FACPAC Contract Change Order Supplemental Information Form (Ref# 56766)

Tier 1 Project: New Jefferson Elementary School

Change Order Number 18-4
Time Extension Required No
Date Of Change Order 9/1/2022

PROPOSAL REQUEST

Attachments: Stair B 300SA; Stair D 200SD; Mechanical Platform B; Exit Lighting Classroom 230; RWL-C

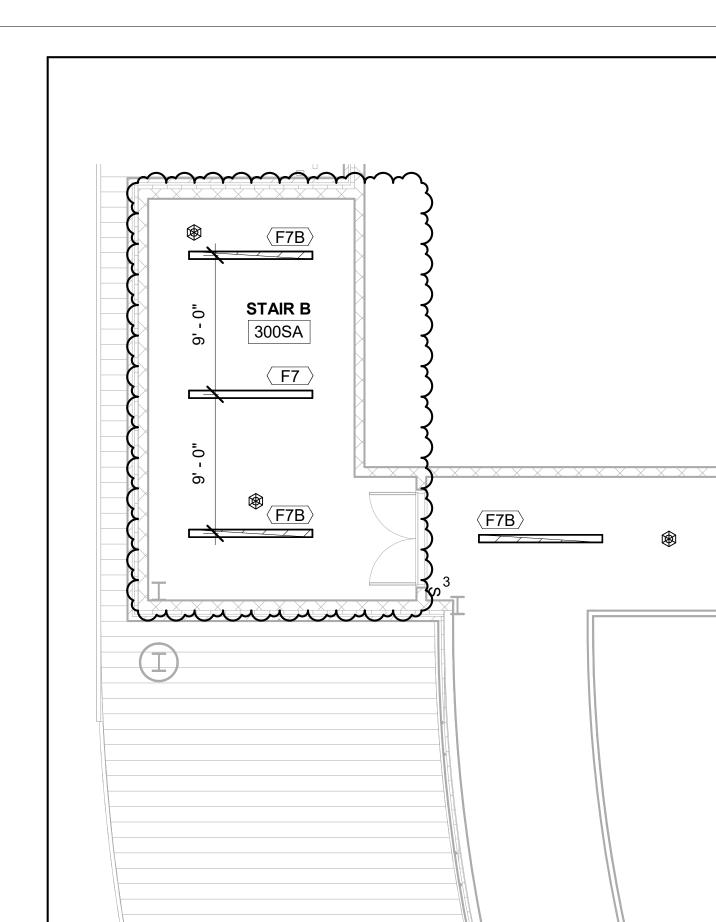
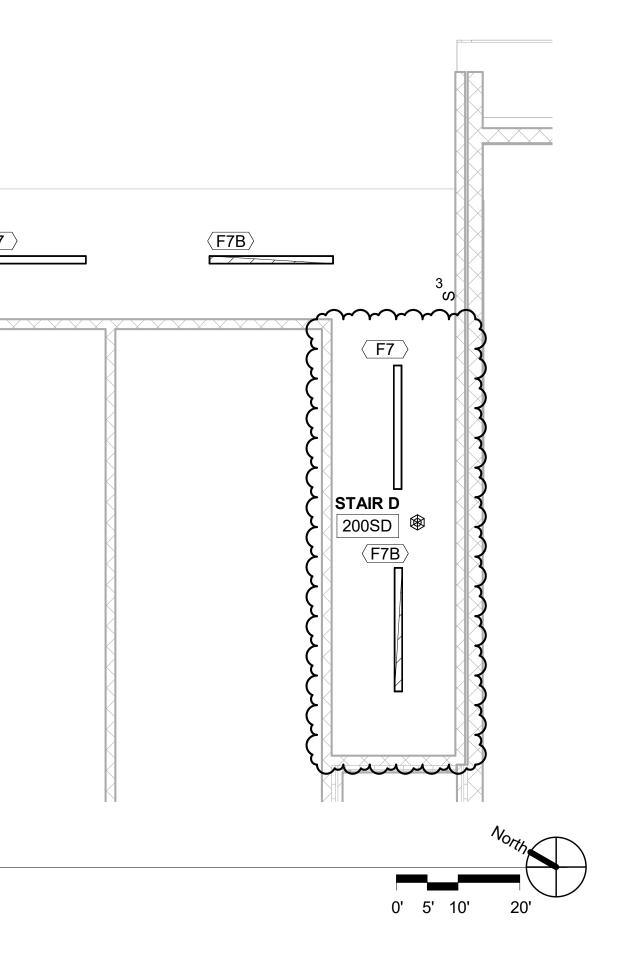
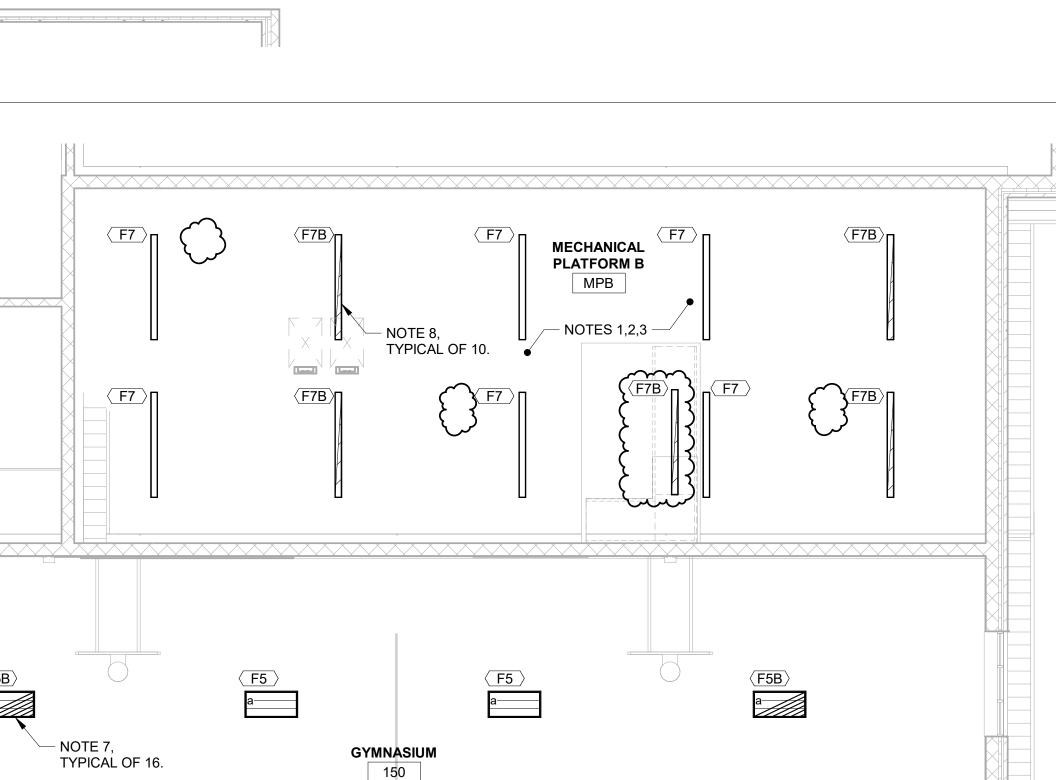
- 1) Provide a price to provide additional light fixtures as shown in the attached drawing Stair B 300SA. Provide all labor and material to connect light fixture power and control to branch circuit and controls serving light fixtures in lower stairwell B.

- 2) Provide a price to provide additional light fixture as shown in the attached drawing Stair D 200SD. Provide all labor and material to connect light fixture power and control to branch circuit and controls serving light fixtures in Mechanical Platform A.

- 3) Provide a price to provide additional light fixture as shown in the attached drawing Mechanical Platform B. Light fixture shall be located within stairwell 100SE leading up to Mechanical Platform B.

- 4) Provide a price to provide exit light fixture as shown in the attached drawing Exit Lighting Classroom 230. Provide back-box extensions as required to mount exit fixture to wall. Refer to attached cut sheet for exit fixture type. Connect exit fixtures to branch circuit serving fixtures in adjacent corridor.

Provide additional "hot" unswitched conductor for correct operation of fixture with integral battery back-up system.

Attachments: ASI-029 M1.1, ASI-029 M1.1A, ASI-029 E2.1

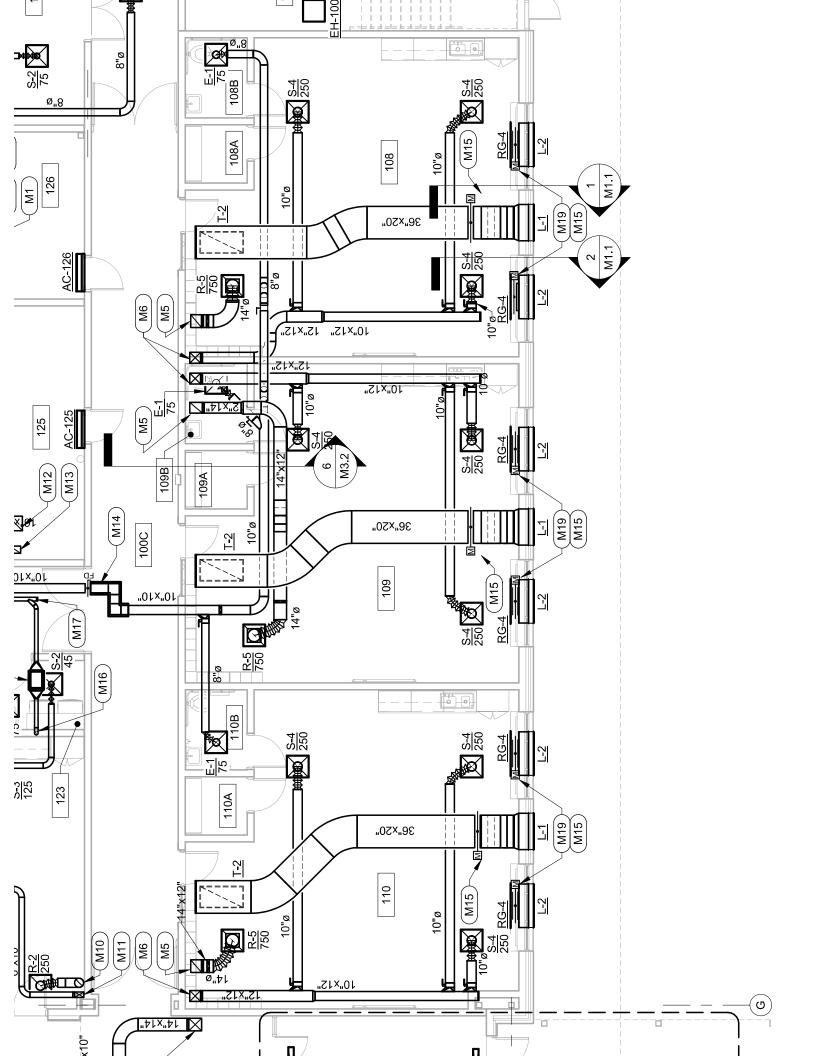
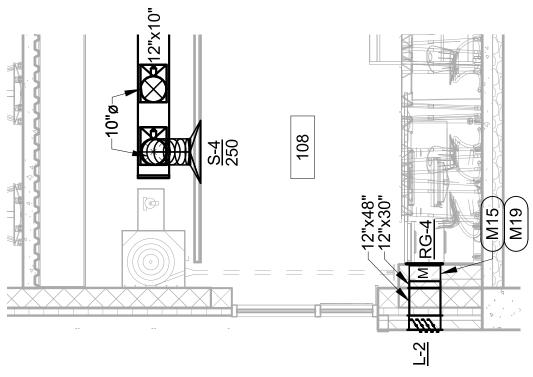
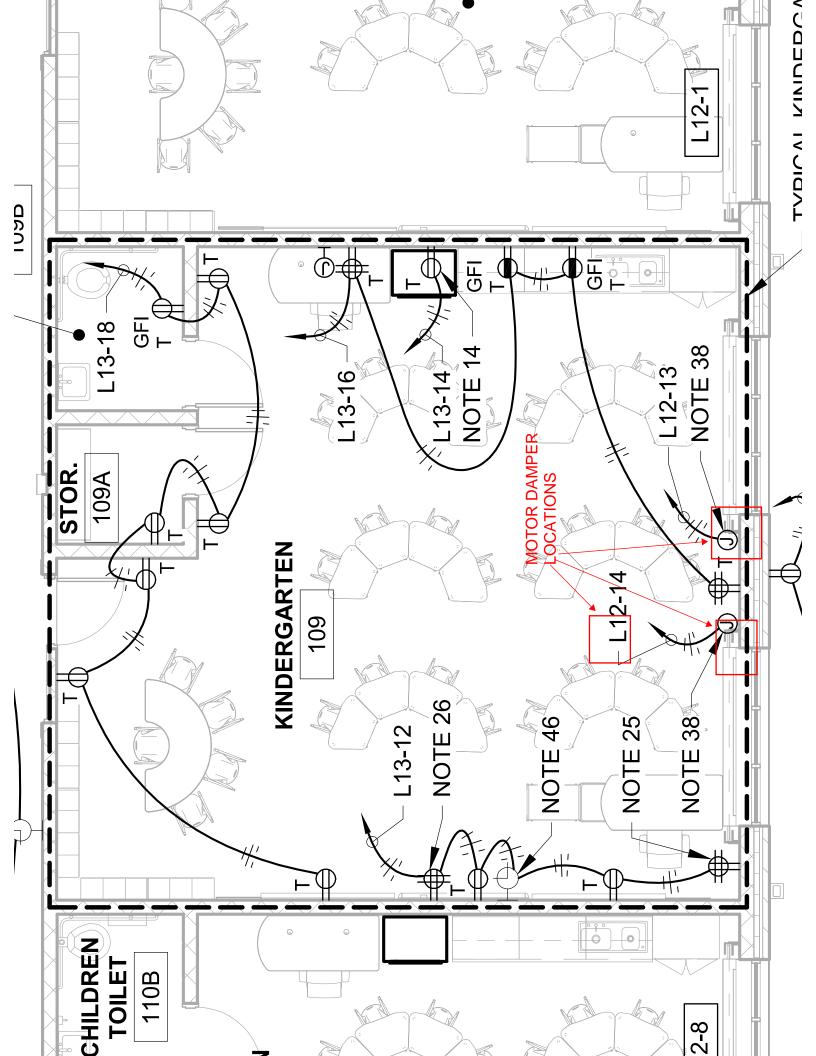
RE: Electrical Circuit to Below Window Damper in Rooms 108,109,110

1. Provide 120V circuit to below and above window dampers in classroom 108, 109, and 110. Coordinate with engineer in field for pathway to motor damper below window. Utilize dedicated branch circuit feeding storm shutter to power motor damper. Provide final connection to motor damper per manufacturer's requirements. Refer to attached drawings for additional requirements.

This quote is acceptable, but so the contractor knows, it is acceptable for providing labor and materials to connect <u>ALL</u> dampers. That is, 3 dampers per room, for a total of 9. As shown in ASI-029, provided in December of last year, when running this circuit didn't involve a finished classroom. Thank you,
